APPEAL SUMMARY

Appeal ID: 16541	Project Address: 5990 SE 92nd Ave
Hearing Date: 2/28/18	Appellant Name: Masaye Hoshide
Case No.: M-004	Appellant Phone: 5038927104
Appeal Type: Mechanical	Plans Examiner/Inspector: Thomas Ng
Project Type: commercial	Stories: 5 Occupancy: R-2, A-2,A-3, S Construction Type: V-A, I-A
Building/Business Name: Oliver Station	Fire Sprinklers: Yes - fully sprinklered
Appeal Involves: Erection of a new structure	LUR or Permit Application No.: 16-220000-CO
Plan Submitted Option: pdf [File 1] [File 2] [File 3]	Proposed use: Affordable Housing

Code Section 2014 Oregon Mechanical Specialty Code; 503.1.1, 2, Location of Exhaust Outlets

EXHIBIT A: LEVEL 1

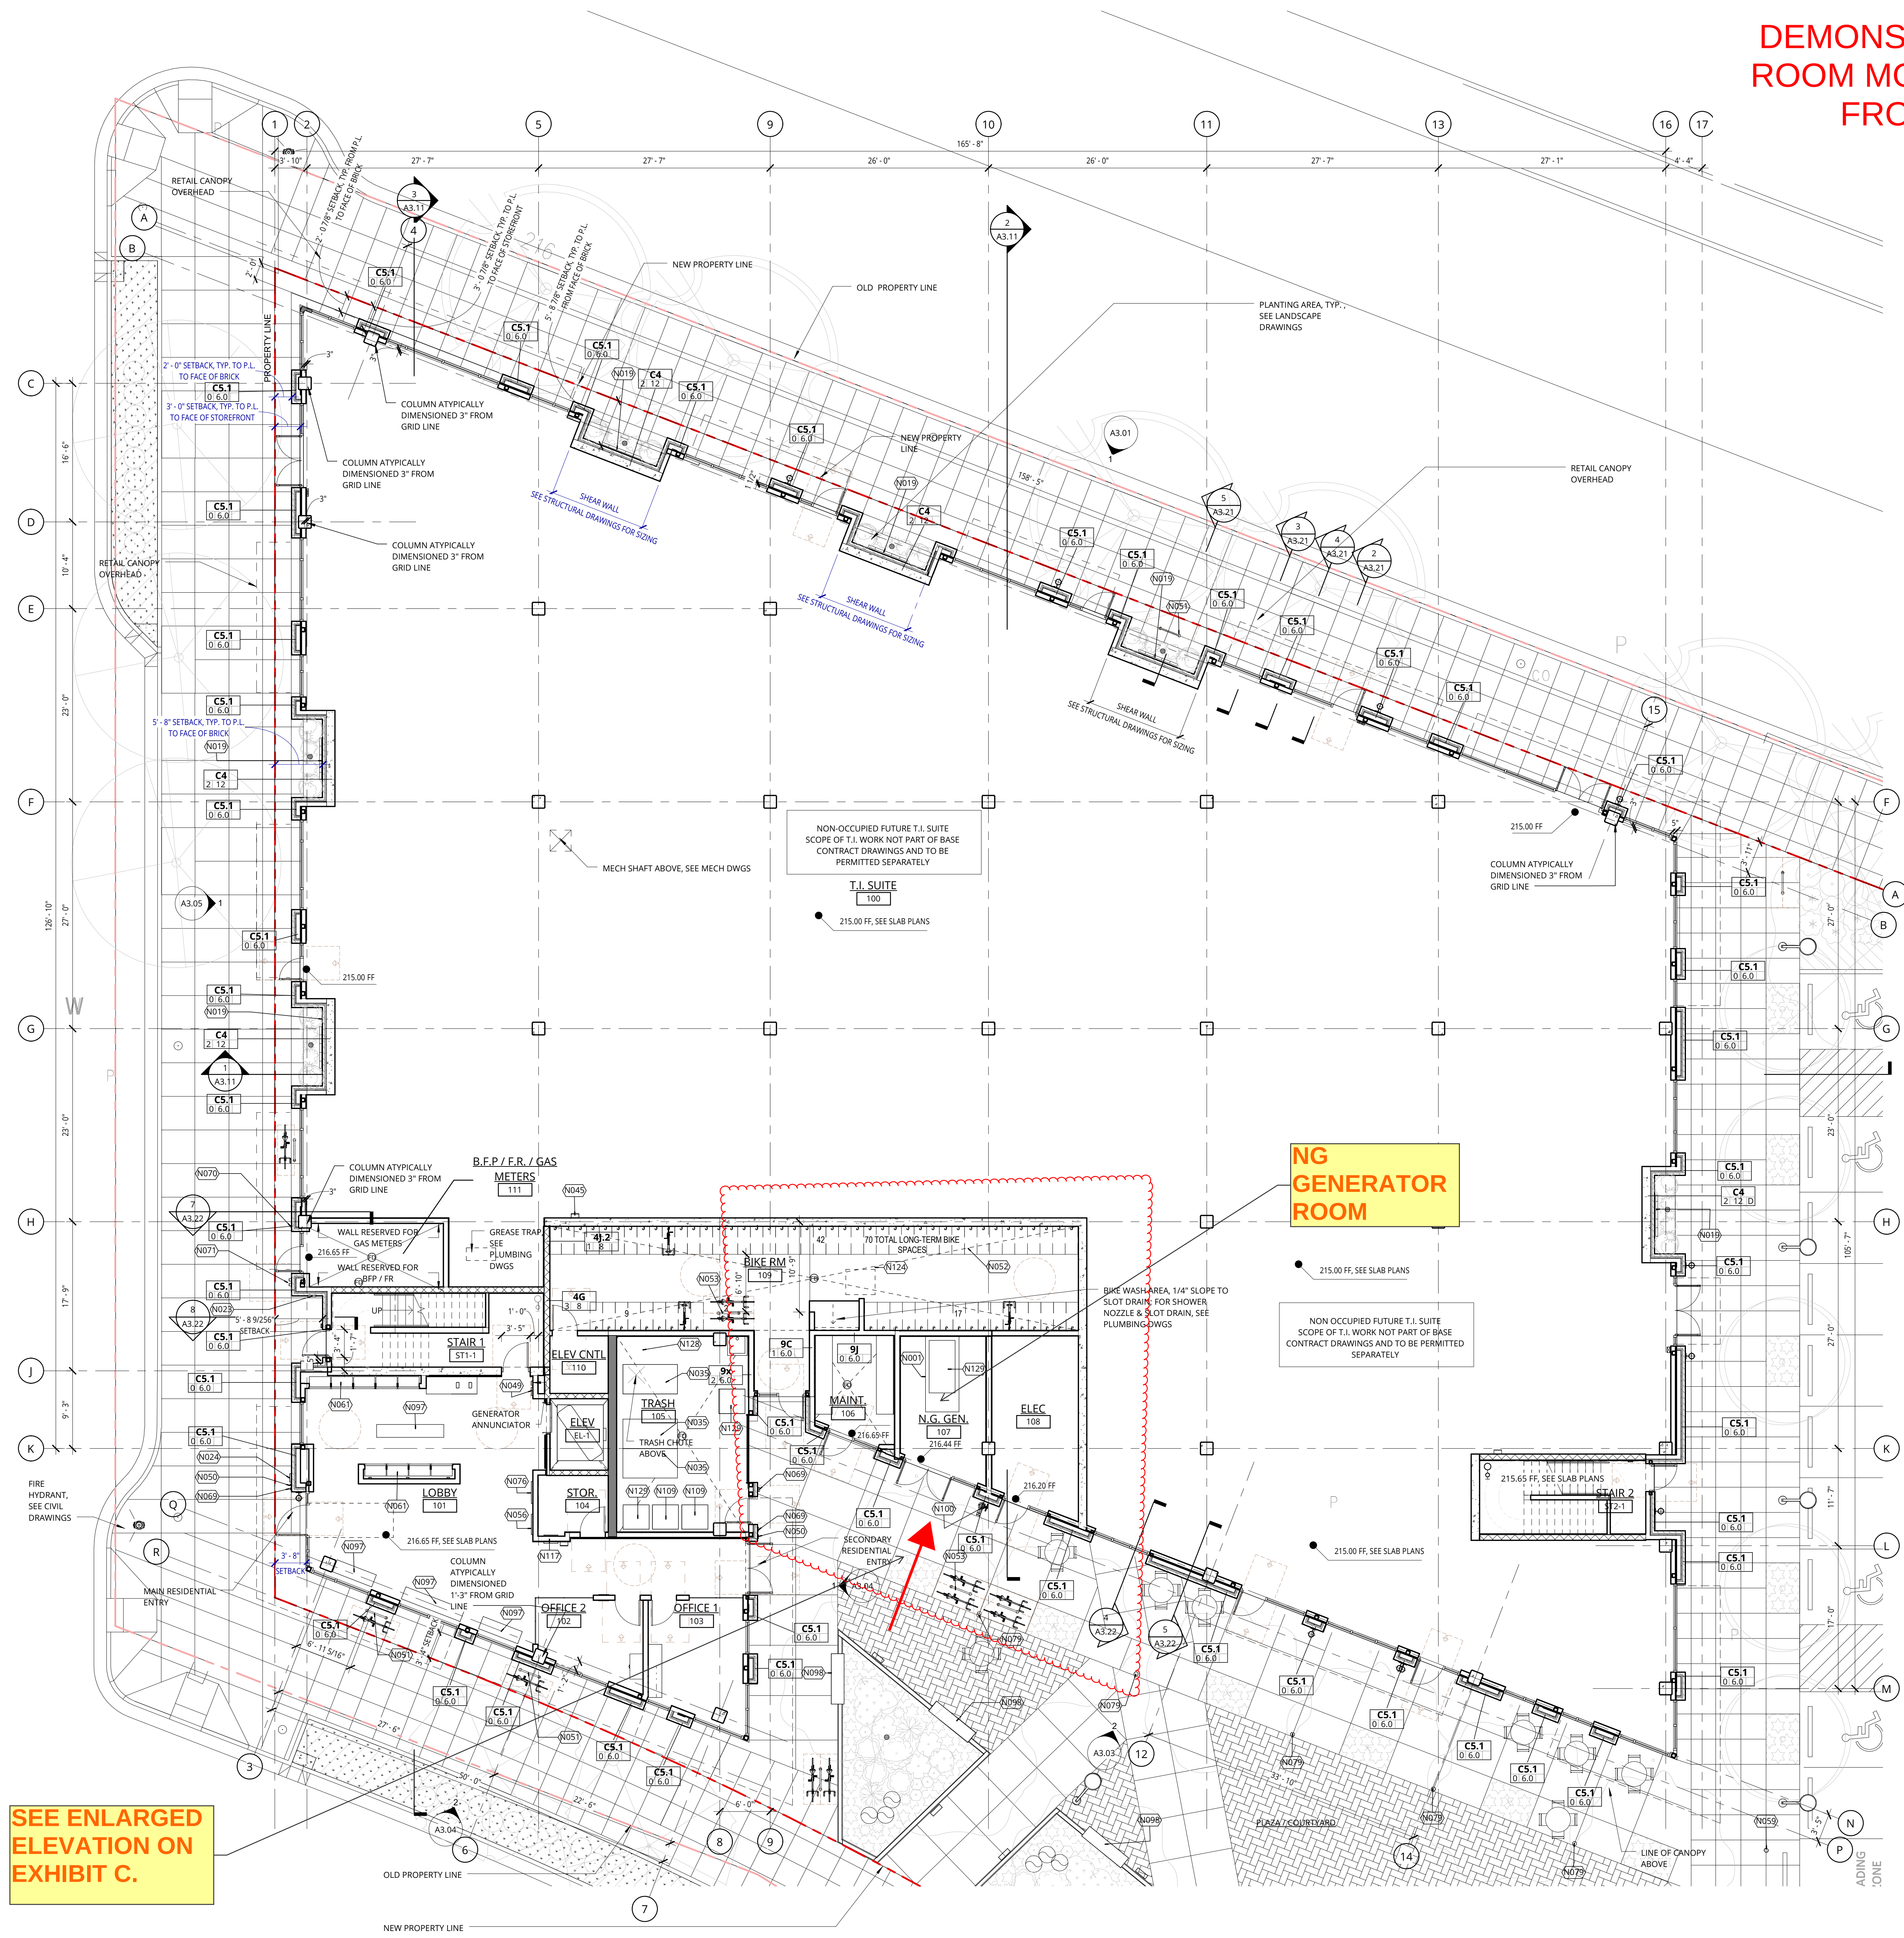
DEMONSTRATES NG GENERATOR ROOM MORE THAN 10 FEET CLEAR FROM PROPERTY LINES

EXHIBIT C: EAST BLOCK,
ENLARGED ELEVATION OF NG
GENERATOR ROOM

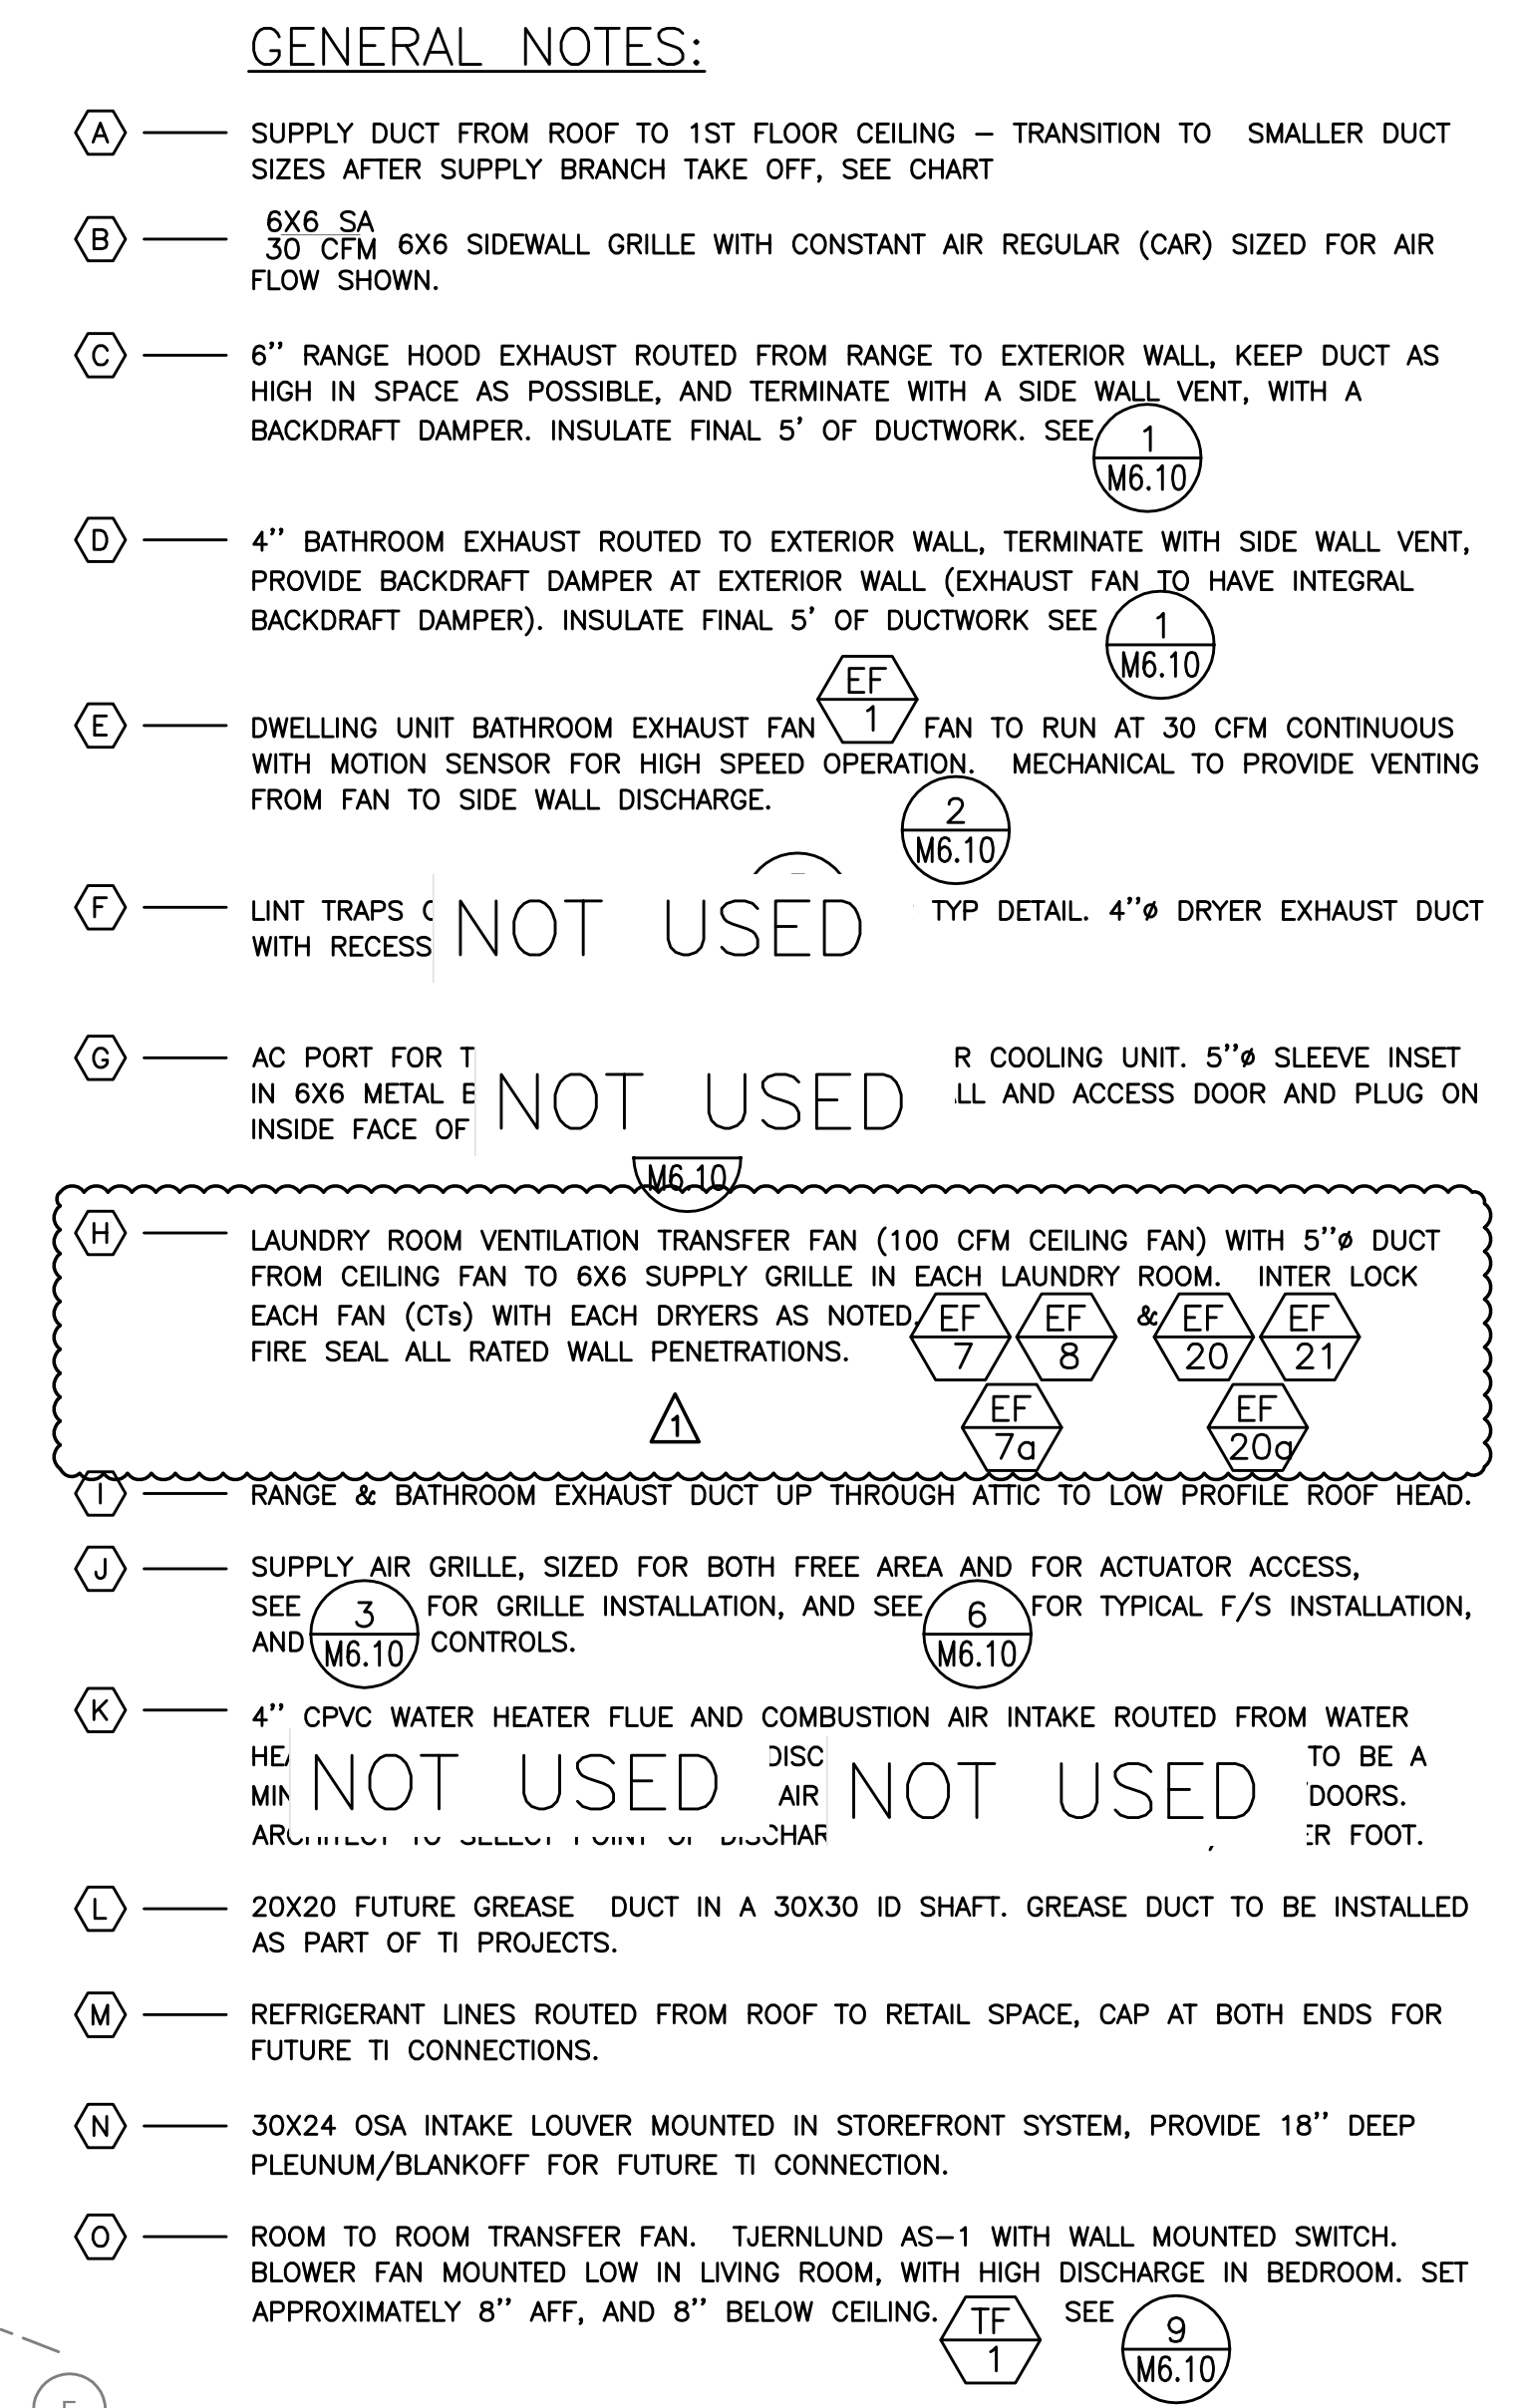
Per City reviewer code interpretation, City reviewer is requiring 3" muffler exhaust to exhaust through roof and 10 feet away from roof edge. Per city reviewer definition of 'operable openings into buildings' includes exhaust louvers.

The proposed design is to have clearance per 2014 OSMC 501.3.1 item 2 for product conveying outlets. This has a 10' clearance to operable openings and property lines. This proposed design does not equate exhaust louvers as operable openings into buildings. This proposed design equates exhaust louvers to be operable openings away from buildings. Therefore, the 10 feet clearance from operable openings into buildings should be allowed to overlap with louvers exhausting environmental air. With this overlap, the 3" exhaust muffler would exhaust horizontally and not through the roof above.

We believe it is incorrect to define exhaust louvers exhausting environmental air as operable openings into buildings. Exhaust louvers function to exhaust air away from buildings. While the generator 3" muffler flue runs intermittently to either test the emergency equipment or during actual emergency operation, the adjacent exhaust louvers will be exhausting environmental air away from the building making it physically impossible for flue exhaust to travel back into the building via the exhaust louvers. Exhaust louvers should not be defined as operable openings into buildings. See attached building plans and elevations which demonstrate compliance of the location of the 3" generator muffler per 2014 Oregon Mechanical Specialty Code; 503.1.1, 2, Location of Exhaust Outlets

Exhaust vent within 10 feet of operable opening: Hold for additional information.
Appellant may contact Thomas Ng (503 823-7434) with questions.
